UNITED STATES PATENT AND TRADEMARK OFFICE

APPLICATION NO.	FILING DATE	FIRST NAMED INVENTOR	ATTORNEY DOCKET NO.	CONFIRMATION NO.
10/789,998	03/02/2004	Takafumi Terahara	1344.1134	3584
21171	7590	09/26/2007		
STAAS & HALSEY LLP SUITE 700 1201 NEW YORK AVENUE, N.W. WASHINGTON, DC 20005			EXAMINER LIU, LI	
			ART UNIT 2613	PAPER NUMBER
			MAIL DATE 09/26/2007	DELIVERY MODE PAPER

Office Action Summary	Application No. 10/789,998	Applicant(s) TERAHARA, TAKAFUMI	
	Examiner Li Liu	Art Unit 2613

DETAILED ACTION

Figure O1

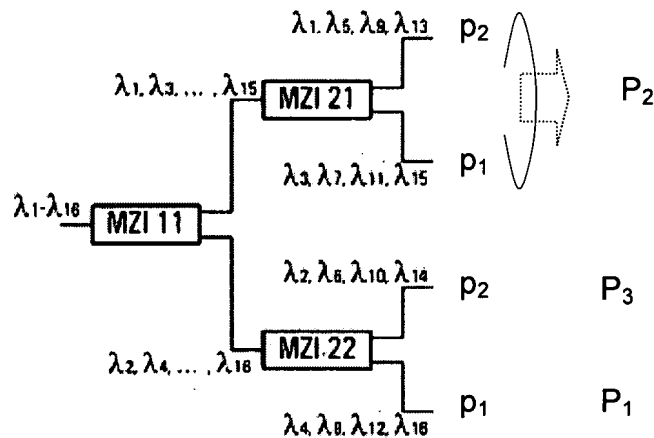
Applicant's argument – "FIG. 3 of Ahmadvand clearly illustrates that the alleged virtual N-1 branch ports output both even-numbered and odd-numbered wavelengths".

Examiner's response – As shown in Fig. 3 and the following Figure O1 (the simplified Figure 3 of Ahmadvand), Ahmadvand clearly shows that the MZI 21 outputs only the odd-numbered wavelengths and the MZI 22 outputs only the even-numbered wavelengths.

That is, Ahmadvand teach "said branch port connecting section groups two or more branch ports of said M branch ports, and virtually considers these as N-1 branch ports outputting one of even-numbered or odd-numbered wavelength groups.

As shown in Figure O1, the output ports p1 and p2 from MZI 21 of Ahmadvand can be grouped together and viewed as "one branch port" P2, and connected to other ports to "virtually" form N-1 branch ports.

Figure O2

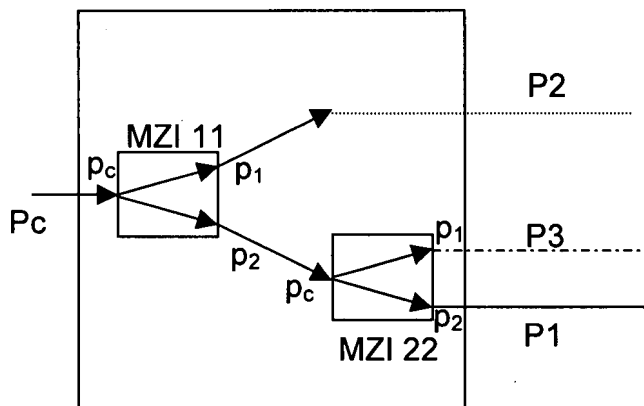
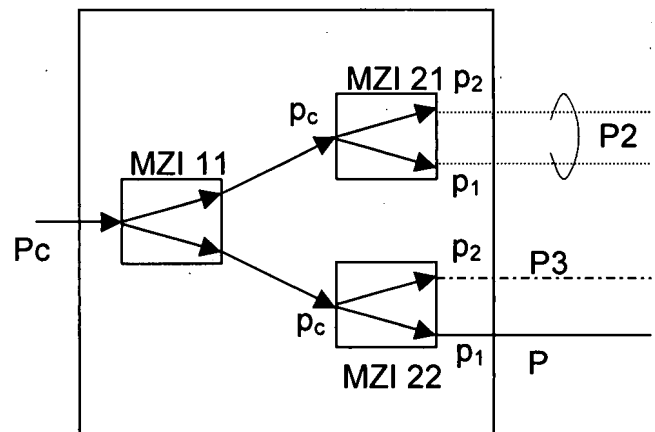
However, the cascading of two or more multiplexers/demultiplexers is a common practice in the art, as disclosed by Ahmadvand et al (Figure 3). And wherein when $N \geq 4$,

for the optical multiplexing/demultiplexing devices, one common port (P_c in Figures O2 and O3 above) and $N-1$ branch ports (three branch ports P_1 , P_2 and P_3) are formed by cascade connecting a plurality of devices each having one common port (p_c in Figure O1) and two branch ports (p_1 and p_2 in Figure O2). Ahmadvand et al's devices relaxes the requirement of having very sharp frequency response in the first demultiplexer of the tree structure.

Figure O4

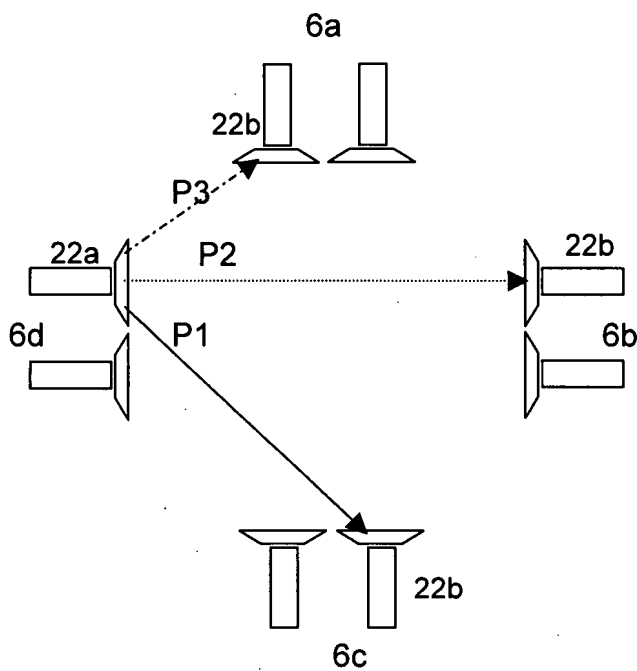
In telecommunication, the "virtual" is something that pretends to be something it isn't, but can be made to appear to be that thing. In Figure O4, the P2 can be also considered to **virtually** have two links because two wavelength channels are presented in the one fiber link.

And more, as shown in Figures O5, to use two fiber links to transmit two wavelengths channels individually do not define a patentably distinct over that in Figure O4 which uses one fiber to transmit two wavelength channels since both configuration are directed to transmit two wavelength channels from 22a to 22b; the function and result of the two structures are exactly the same.

Figure O5

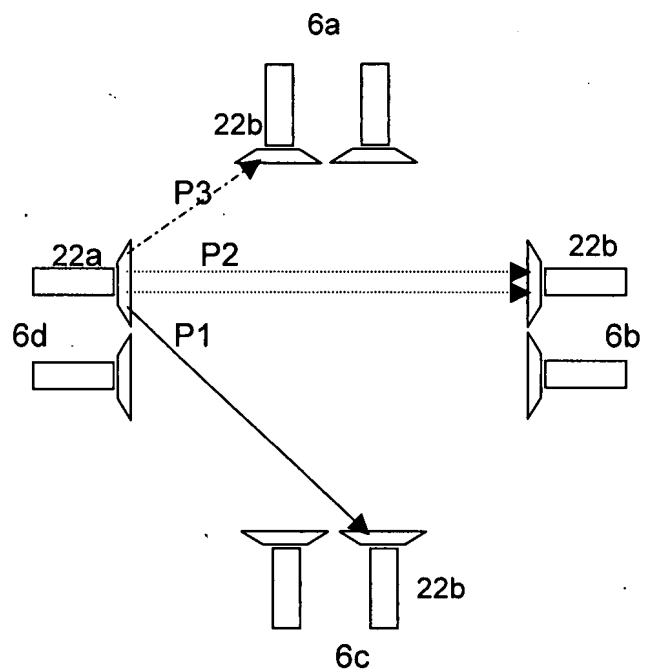
In McMahon's system, four multiplexing/demultiplexing devices $N = 4$ (6a – 6d in Figures 3 and 4), so the $M > N-1$. Therefore, when a similar cascading device is used in the system of McMahon, the two outputs from MZI 21 can be grouped together and connected to another two ports of other ports of other multiplexing/demultiplexing device (e.g., the 22b in 6b in Figure O5 above).

As shown in Figure O5, when physical branch ports is four, and there are only three multi/demultiplexing devices 22b to receive the signals from 22a, the fourth port can be connected to any one of the multi/demultiplexing devices 22b since each of the devices 22b also has four branch ports.
